## JOINT REGIONAL PLANNING PANEL (East Region)

JRPP No	2014SYE139
DA Number	14/207
Local Government Area	City of Botany Bay
Proposed Development	<p>Integrated Development and Joint Regional Planning Panel:-</p> <ul style="list-style-type: none"> <li>• Demolition of existing structures;</li> <li>• Construction of a serviced apartments complex:- <ul style="list-style-type: none"> <li>- One (1) level of basement car parking for 115 vehicles and bicycle storage, 18 car spaces at ground level (total car parking of 133 spaces) with 3 drop-off/pick-up spaces at the front of the building from Robey Street;</li> <li>- Eight (8) storey building comprising 152 serviced apartments with, retail space, pool, guest dining area, meeting room on the ground floor; and</li> <li>- Loading dock and service areas on the ground floor accessed from Baxter Road;</li> </ul> </li> <li>• Through-site link between Baxter Road &amp; Robey Street;</li> <li>• Publicly accessible playground;</li> <li>• Construction of 3 storey warehouse/office building fronting Baxter Road and loading dock at ground level and single storey warehouse fronting Robey Street.</li> <li>• Lot consolidation and subdivision into two (2)

Figure 12: Height Exceedance (Source - Applicant's Cl 4.6 Variation)

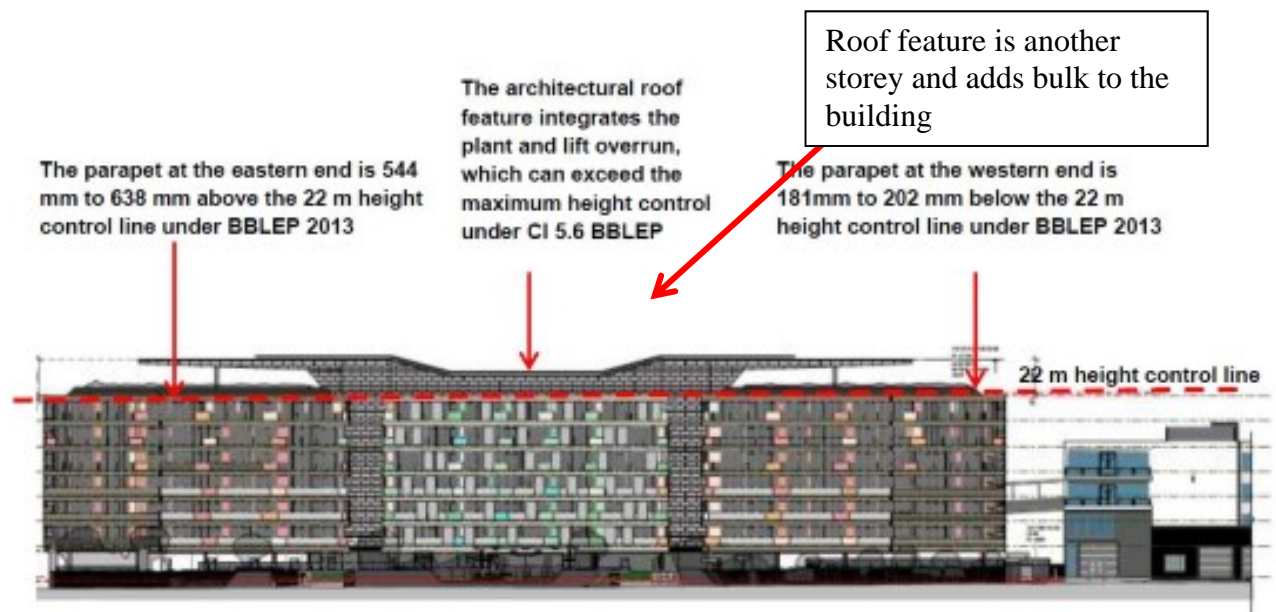
The roof of the main portion of the building (up to Level 6 (7<sup>th</sup> floor)) is between 202mm below (NW corner) to 638mm (SE corner) above the maximum height limit. The height to the top of the penthouse level on Level 7 (8<sup>th</sup> floor) exceeds the height limit by between 3.948m (NW corner) to 4.15m (SE corner). The overall heights are 25.95m (NW), 25.97m (SW) and 26.69m (NE). the height variation is illustrated in **Figure 12** from the applicant's Clause 4.6 variation.

It should be noted that this Clause 4.6 variation has been prepared on the basis of the variation to the height to the top of the parapet to Level 6 and ignores the height non-compliance of the rooftop garden level (Level 7) which contains a plant room and lift motor room.

Building height is defined in the Dictionary to BBLEP 2013 as “*the vertical distance between ground level (existing) and the highest point of the building, including plant and lift overruns, but excluding communication devices, antennae, satellite dishes, masts, flagpoles, chimneys, flues and the like*”. Therefore, the height of the building is the measurement to the top of Level 7, which contains plant and lift overruns.

Figure 13 – Setback to Baxter Road

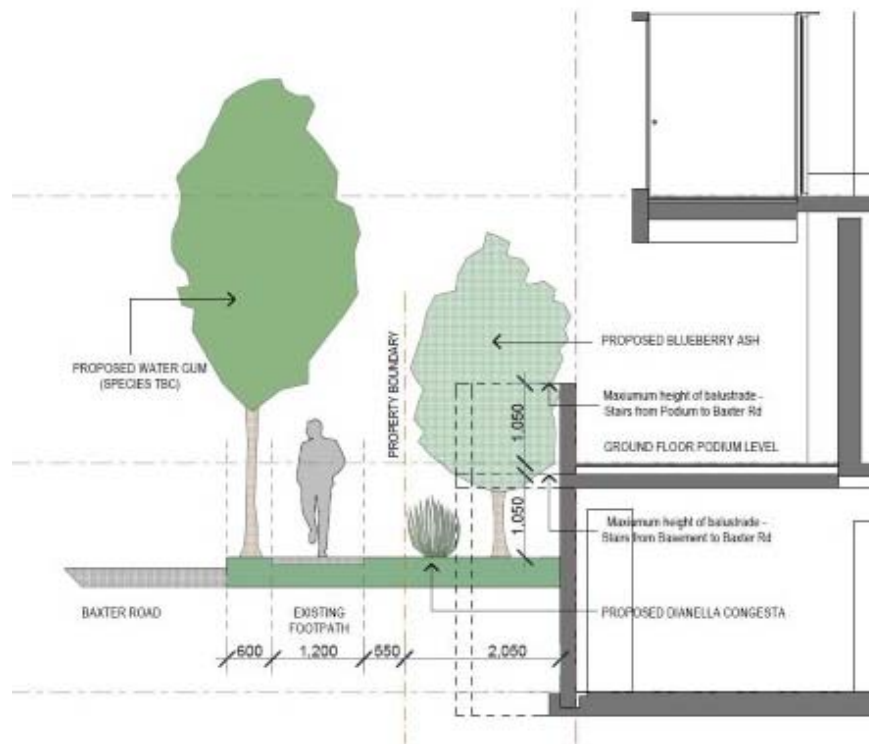
The setbacks of the proposal generally comply with the DCP requirements, although the Baxter Road frontage should also be considered in the context of front setback controls. The setback to Baxter Road was amended in plans received in February with the building moved slightly closer to the Robey Street boundary, increasing the setback to Baxter Road by 600mm. No further setback to Baxter Road can be achieved due to the required ramp grades and entry to the basement parking along the Robey Street frontage.

The setback to Baxter Road at the ground floor is now between 2.050 metres to the ground floor terrace and 5.7 metres to the building face. The ground floor terrace involves a wall of approximately 2.1 metres high which is a combination of the roof of the basement and the podium of the ground floor terrace wall. The upper levels are setback between 3 metres and 7.45 metres. A cross section of this setback to Baxter Road is illustrated in **Figure 13**.

This setback to Baxter Road allows for significant tree planting as outlined in the cross section, totalling approximately 31 densely planted 5 metre high blueberry Ash trees in addition to other trees and shrubs and street trees within the Baxter Road footpath. While Council's Landscape Officer was concerned that this Baxter Road streetscape was not wide enough for street trees, the planting schedule proposed is considered to be suitable for its location and is supported. Taken together, this landscaping will assist in minimising bulk to the streetscape from the proposal. The resulting setback to Baxter Road is considered acceptable and is generally consistent with existing buildings on this street including the Rex building adjoining to the west.
